PLANS AND DOCUMENTS
referred to in the PDA
DEVELOPMENT APPROVAL

Approval no: DEV2026/FLA/4818
Date: 21 August 2026

TRANSPORT ASSESSMENT

PROPOSED WAREHOUSE DEVELOPMENT

FIGURE 4.10 – SWEEP PATH OF B99 VEHICLES (MANOEUVRING)

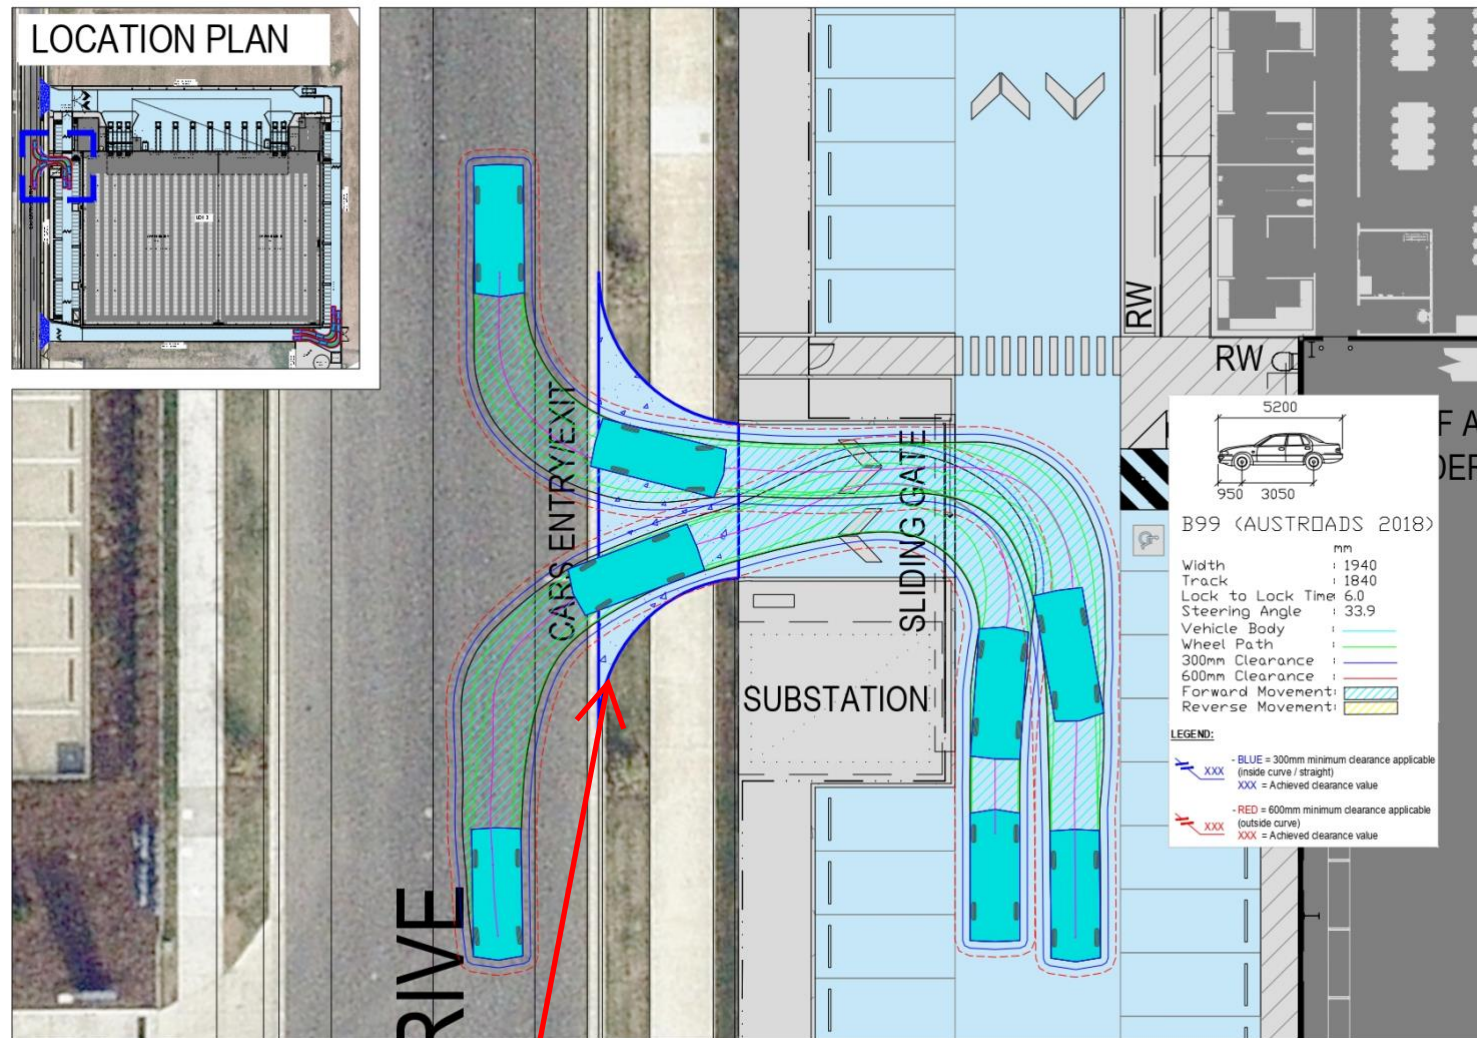
Crossover to be a 6m Wide Tupe "General Wide" Heavy Duty Crossover in Accordance with IPWEA STD DRG RS - 051

FIGURE 5.2 – PROPOSED ACCESS ARRANGEMENTS (CENTRAL CROSSOVER – LIGHT VEHICLE ACCESS TO TENANCY A)

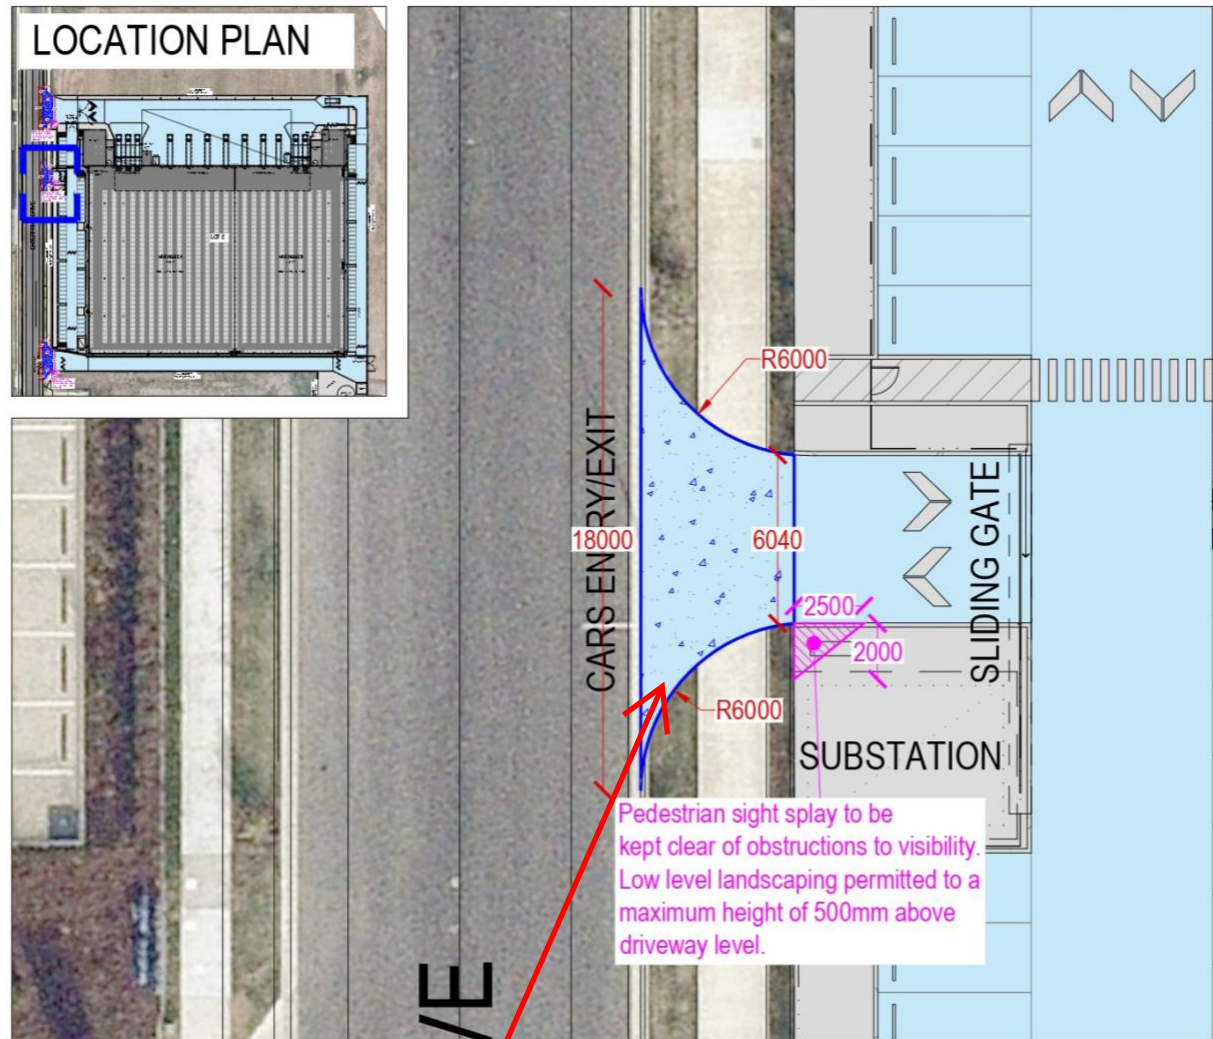
Crossover to be a 6m Wide Tupe "General Wide" Heavy Duty Crossover in Accordance with IPWEA STD DRG RS - 051

FIGURE 6.4 – VEHICLE SWEEP PATHS (ARTICULATED VEHICLE)

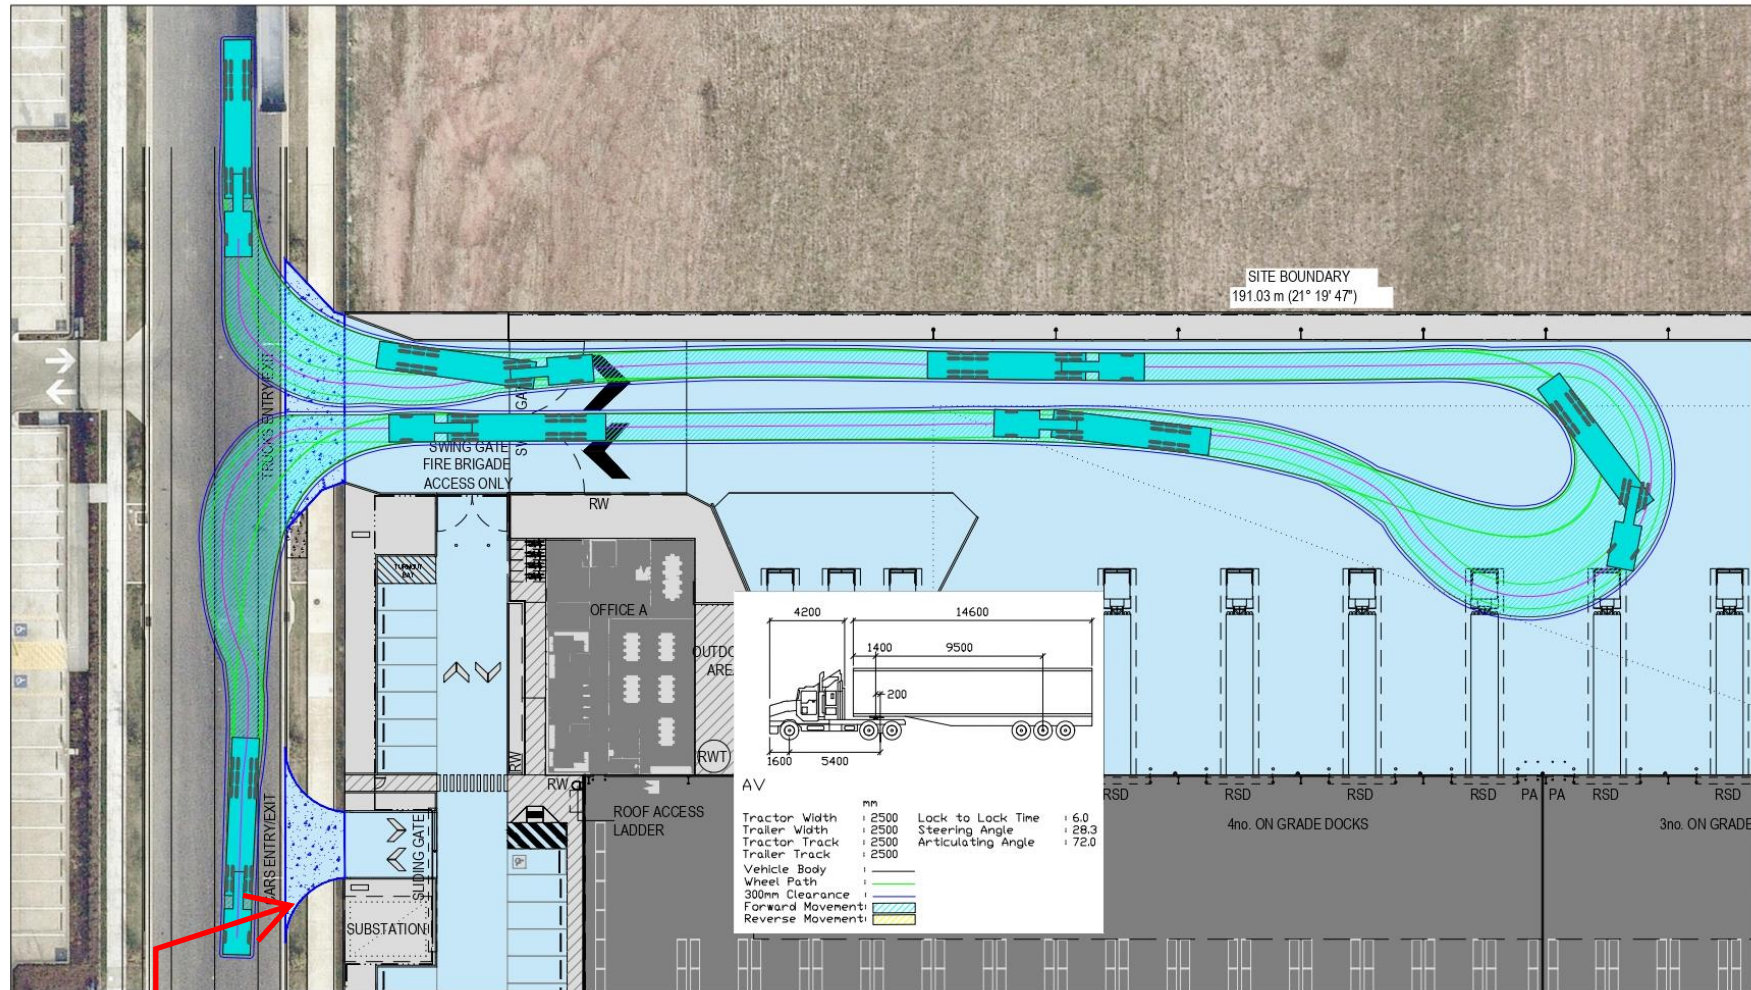
Crossover to be a 6m Wide Tupe "General Wide" Heavy Duty Crossover in Accordance with IPWEA STD DRG RS - 051
